RAYMORE PLANNING AND ZONING COMMISSION AGENDA

To: Planning and Zoning Commission
From: City Staff
Date: October 3, 2017
Re: Case #17028 - Site Plan: Cunningham at Creekmoor Community Pool

To: Planning and Zoning Commission
From: Michael Krass; Director of Public Works
CC: File
Date: September 26, 2017
Re: Cunningham at Creekmoor Pool Site Plan

CUNNINGHAM 2nd PLAT COMMUNITY POOL

GENERAL LAYOUT

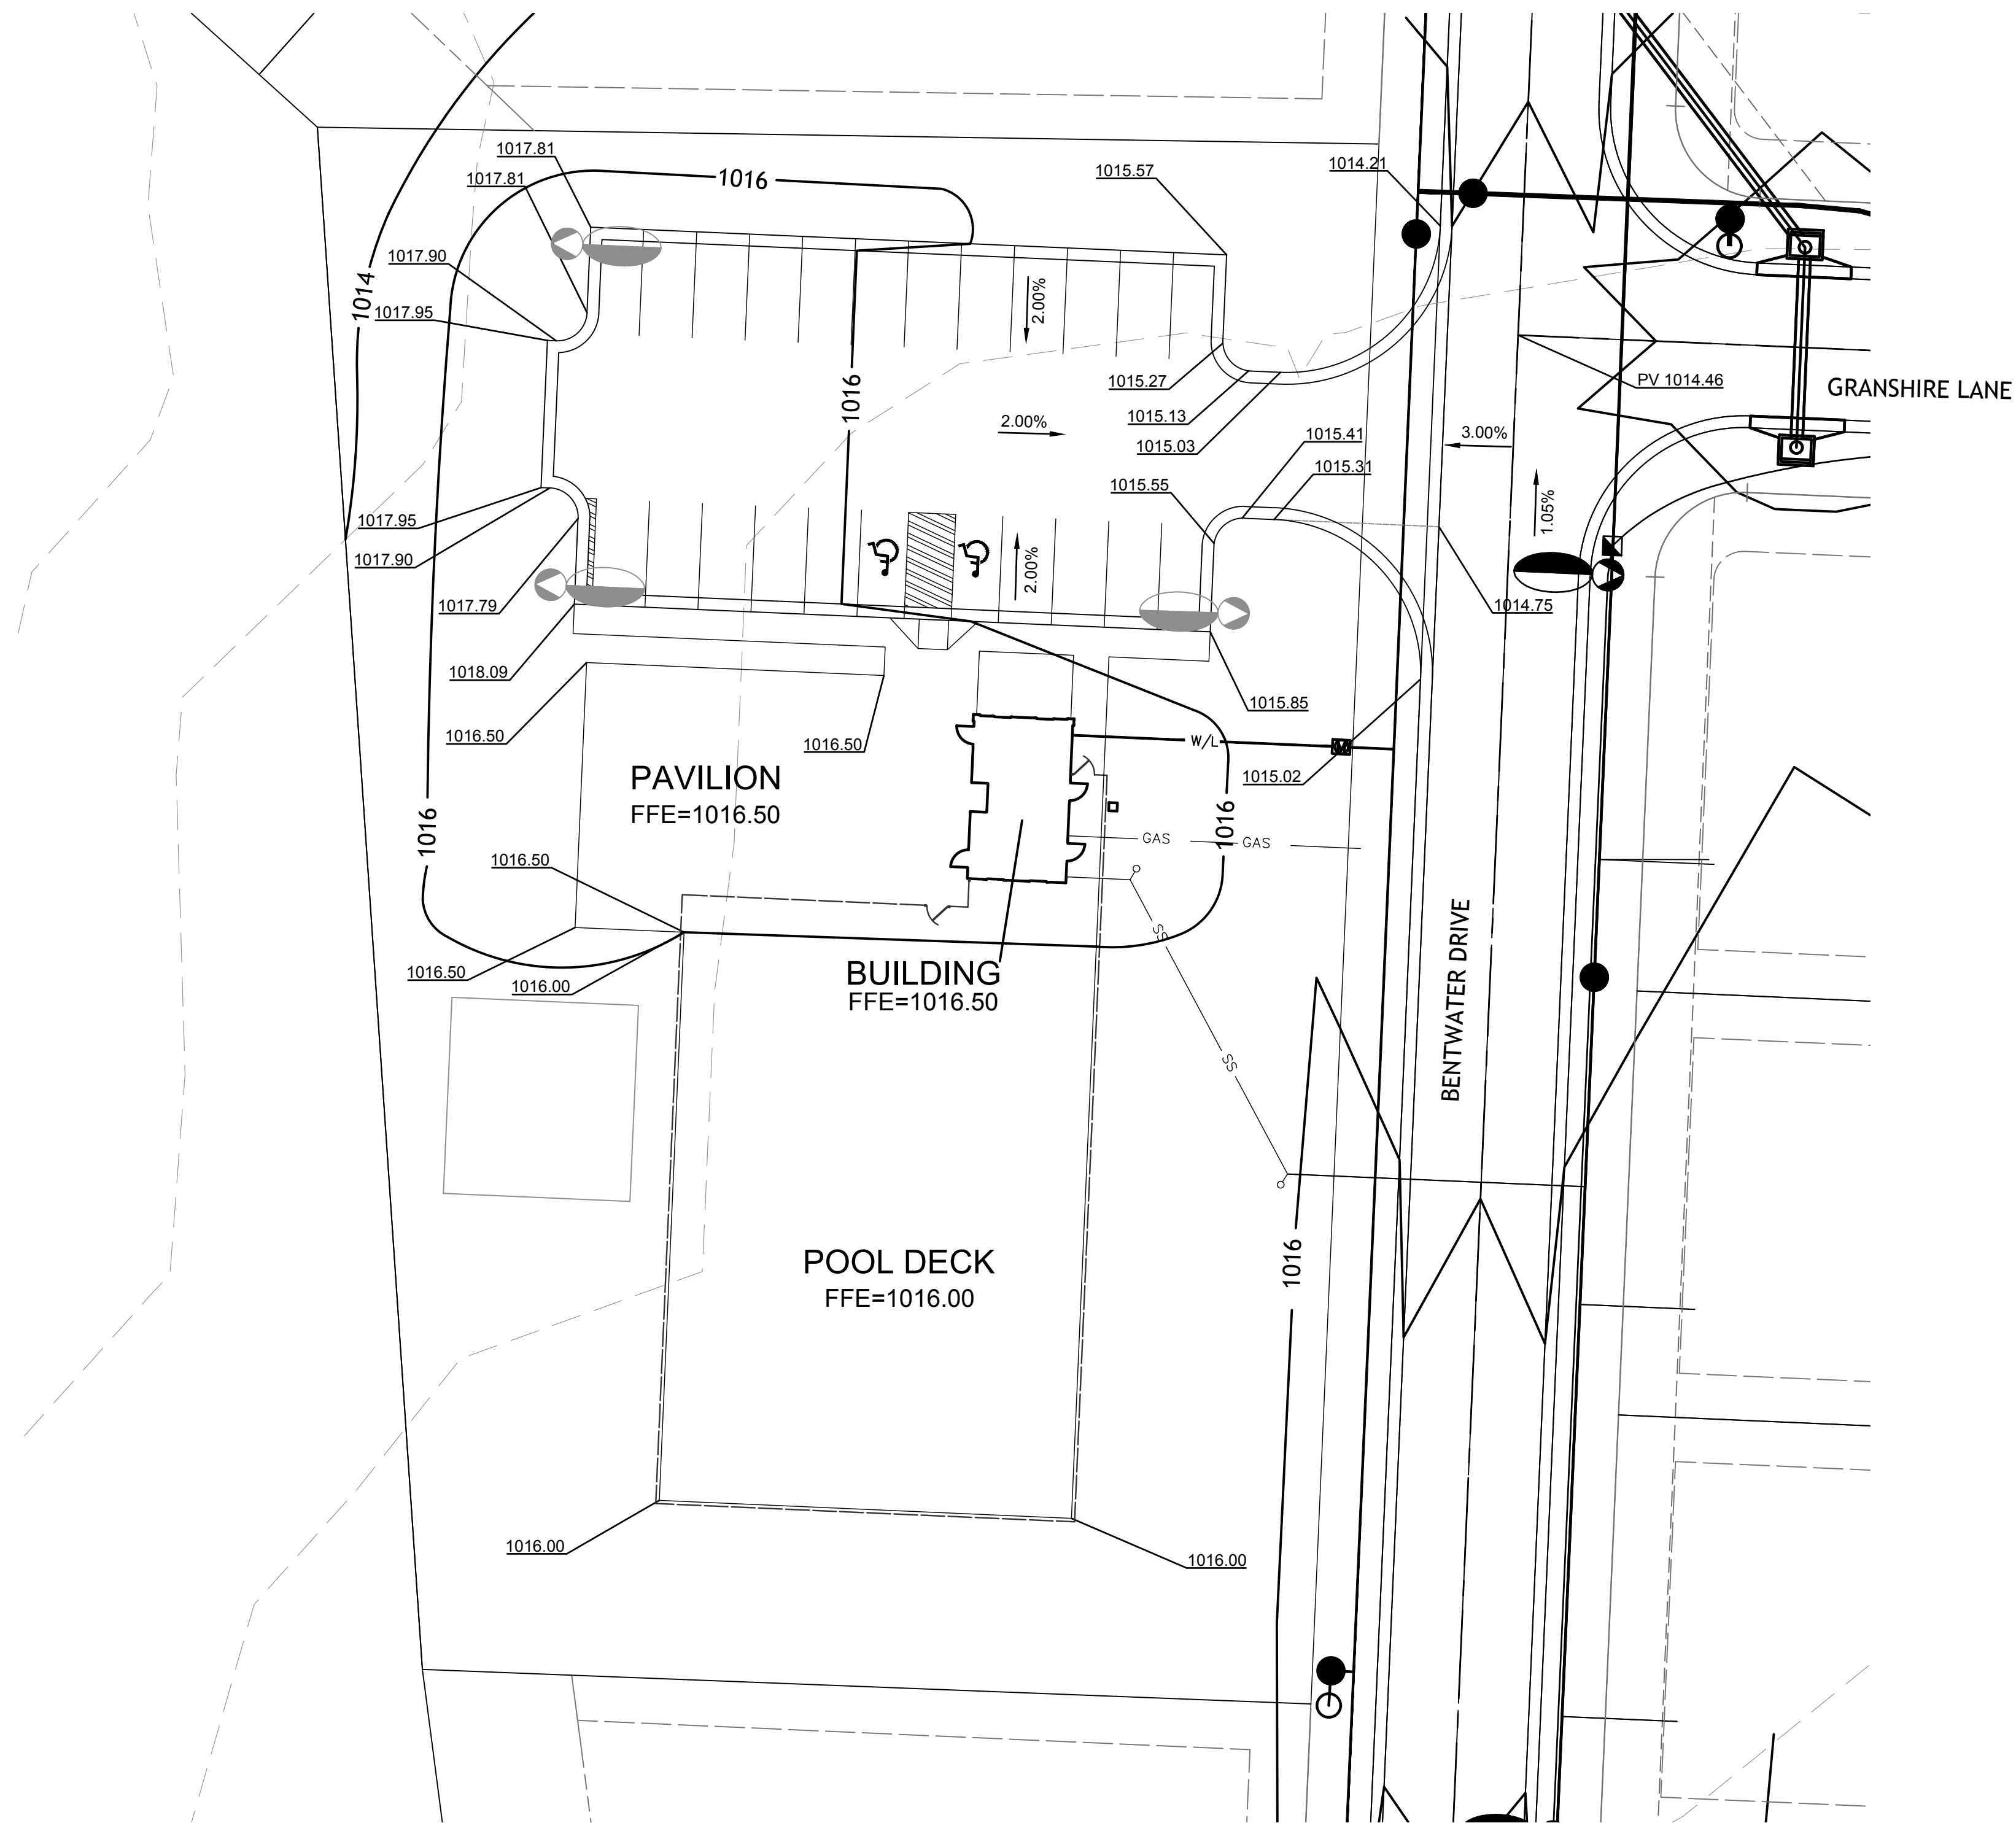
- 14.** The following revisions are required to the site plan prior to the issuance of a building permit.
 - A. The five foot (5') tall fence around the perimeter of the pool shall be six foot (6') in height.

- B. Identify the location of the concrete washout on the Erosion Control Plan.
 - C. Show the sidewalk along Bentwater Drive on the site plan.
 - D. Extend the sidewalk on the north side of the pavilion to connect to Bentwater Drive.

- E. The gate into to pool deck shall open outward, away from the pool.
 - F. The ADA ramp leading into the parking lot shall be centered with the ADA access aisle.

3. Applicant must submit a revised site plan showing revisions A thru G from staff comments.

LANDSCAPE PLAN

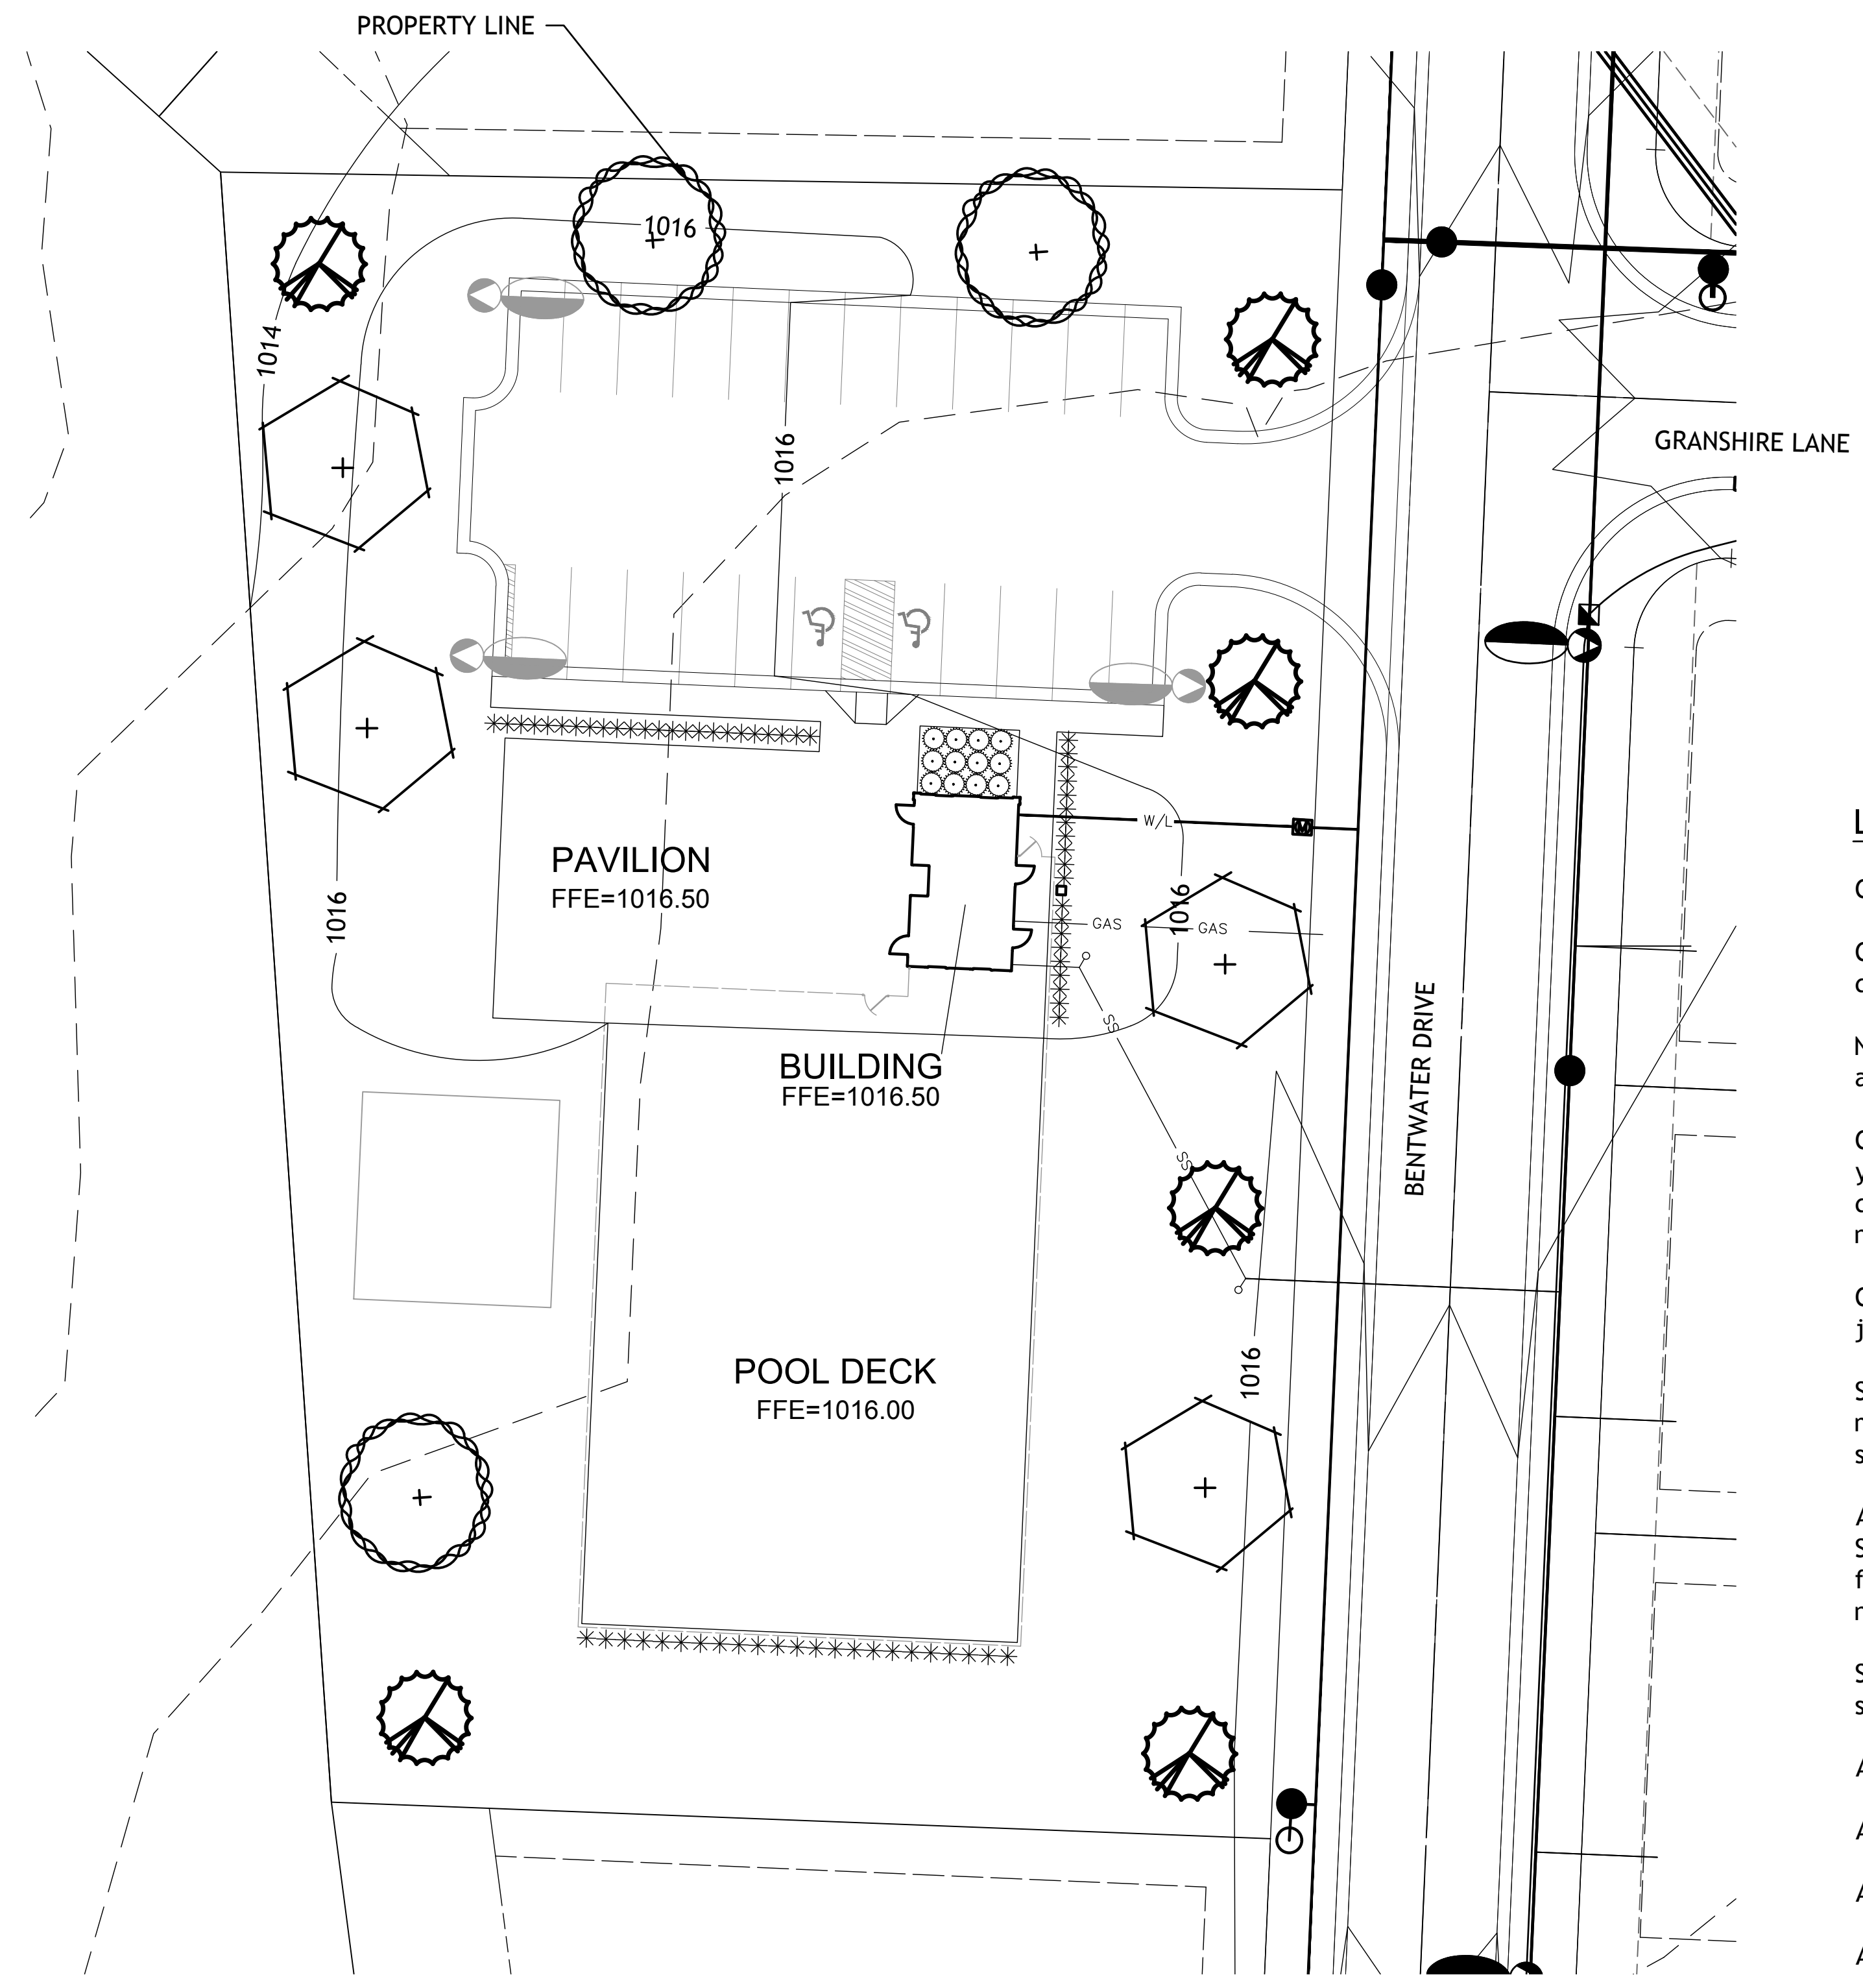
- G. Identify the location of the "Type A" screening on the Landscape Plan between the designated parking area, and abutting residential districts.
